ECE/TRANS/WP.29/GRSG/2008/3
30 January 2008

**REGULATION No. 46
(Devices for indirect vision)**

Proposed amendments to the Regulation

Submitted by the expert from the Netherlands^{*/}

Figure 1 Diagram of the blooming measurement set-up. 1: Black & white background. 2: Lamps to make the background evenly illuminated. 3: Mirror. 4: high intensity light. 5: Camera. 6: Monitor.

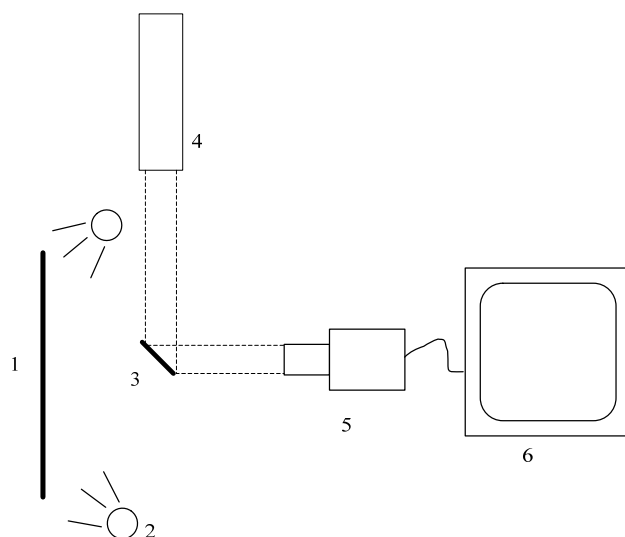
A high-intensity light (e.g., theatre spotlight) is reflected into the image using a small mirror (see Figure 1). The illuminance of the camera by the light reflected from the mirror shall be 40,000 lx. The light source is depicted in the centre of the camera: the light enters the camera from the normal direction. A high contrast black and white pattern (e.g. a checkerboard pattern) is illuminated by a set of lamps to create an even illumination of 3000 ($\pm 25\%$) lx.

The glare source should extend an angle (diameter) of 5° ($\pm 10\%$). A schematic drawing of the set-up is given in Figure 1.

The mirror shall be placed such that its image is positioned in the middle of the pattern. The luminance contrast between the white and black areas in the display image can be

measured. The saturated area is defined by the area in which the contrast of a high contrast test pattern falls below 0.2. The contrast (C) is defined by the difference in luminance between the bright (L_w) and dark (L_b ; black) and regions divided by the luminance of the bright (white) regions:

The saturated area shall not cover more than 10% of the display area.

In case the camera system shows dynamical changes in the blooming area during the test the maximum blooming area should fulfill the requirement."

This new annex contains a detailed measuring set-up for the test in which low sunlight falling on the camera is simulated.

Figure 2 Typical relationship between the size of the triangle and the fraction of correct responses.

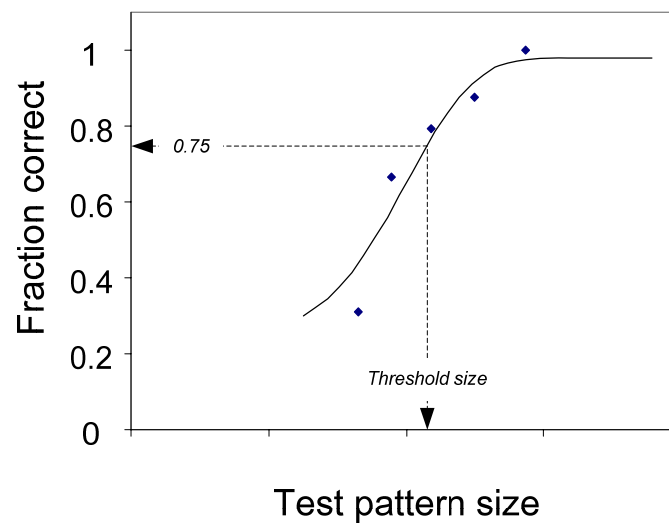
The TNO Landolt C test can be used to determine the smallest discernable detail of the camera-monitor system. However, for sensor systems it is more suitable to use the TOD (Triangle Orientation Discrimination) method which is similar to the Landolt C method, but involves equilateral triangular test patterns. The Triangle Orientation Discrimination method is described in detail by Bijl & Valeton (1999), who provide practical guidelines on how to perform a TOD measurement. In the method, triangular test patterns (see Figure 1) are viewed through the viewing system under test. Each triangle can have one out of four possible orientations (apex up, left, right or down) and the observer indicates/guesses for each triangle its orientation. When this procedure is repeated for many (randomly oriented) triangles of different sizes the fraction of correct responses can be plotted (see Figure 2), and increases with test pattern size. The threshold is defined as the point at which the fraction correct crosses the 0.75 level and can be obtained by fitting a smooth function through the data (see Bijl & Valeton, 1999). Critical perception is reached when the critical object diameter equals two times the width of the triangle at threshold size. The smallest discernable detail (ω_c) is equal to 0.25 times the width of the triangle at threshold size.

The procedure for calculating the maximum detection distance on the basis of video lines has been replaced by a new procedure based on ophthalmologis tests like Landolt-C or TOD (Triangle Orientation Discrimination).
